Access Compliance Report Public Rights-of-Way (Curb Ramps)

Intersection ID: 10029691 Main Street: KINGSLEY VIEW DR **Cross Street: N/A** Location: NW ADA ID: 275C0EB95160 Ramp Type: PerpDiag Initial Pass/Fail: Fail **Overall Compliance: No** Severity Score: 61.25

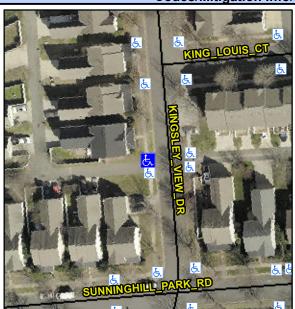
Field Measurements/Component Compliance					
Compliance Description		Data	Comp	liance Description	Data
N/A	Ramp Length (in)	75.0	No	Ramp Slope (%)	13.0
No	Ramp Width (in)	25.0	No	Ramp XSlope (%)	3.4
N/A	Flare Type LT	N/A	N/A	Flare Type RT	N/A
N/A	Flare Slope LT (%)	N/A	N/A	Flare Slope RT (%)	N/A
N/A	Flare Traversable LT?	N/A	N/A	Flare Traversable RT?	N/A
N/A	Landing Length (in)	N/A	N/A	DWS Provided?	N/A
N/A	Landing Width (in)	N/A	N/A	DWS Contrast?	N/A
N/A	Landing Slope (%)	N/A	N/A	DWS Length (in)	N/A
N/A	Landing X Slope (%)	N/A	N/A	DWS Full Width?	N/A
N/A	Landing Curb? (Y/N)	N/A	N/A	DWS Offset (in)	N/A
N/A	Shared Landing?	N/A			
N/A	Gutter Ponding?	N/A	N/A	Gutter Slope (%)	N/A
N/A	Gutter Lip Ht (in)	N/A	N/A	Gutter X Slope (%)	N/A
N/A	Painted X Walk1?	No	N/A	Painted X Walk2?	No
	X Walk 1 Direction	To S		X Walk 2 Direction	To E
N/A	X Walk 1 Width (in)	N/A	N/A	X Walk 2 Width (in)	N/A
	X Walk 1 Slope (%)	4.1		X Walk 2 Slope (%)	3.2

X Walk 1 X Slope (%)	0.7		X Walk 2 X Slope (%)	4.1
N/A	Ramp inside XWalk1?	N/A	N/A	Ramp inside XWalk2?	N/A
	Road Slope (%)	0.5	N/A	Clear Space?	N/A
	Road X Slope (%)	1.3	N/A	Clear Space to XWalk (in)	N/A
N/A	Any Obstructions?	N/A	N/A	Storm Grate/Utility Hazard?	N/A
	Obstruction Type			Storm Grate/Utility Type	
		N/A			N/A
			Yes	Surface Condition? (G/P)	Good

Possible Solutions: Remove & Replace Curb Ramp With **Two New Directional Ramps or** Equivalent. Surveyor Notes: N/A PROW/ADA: R304.5.1, R304.2.2, R304.5.3
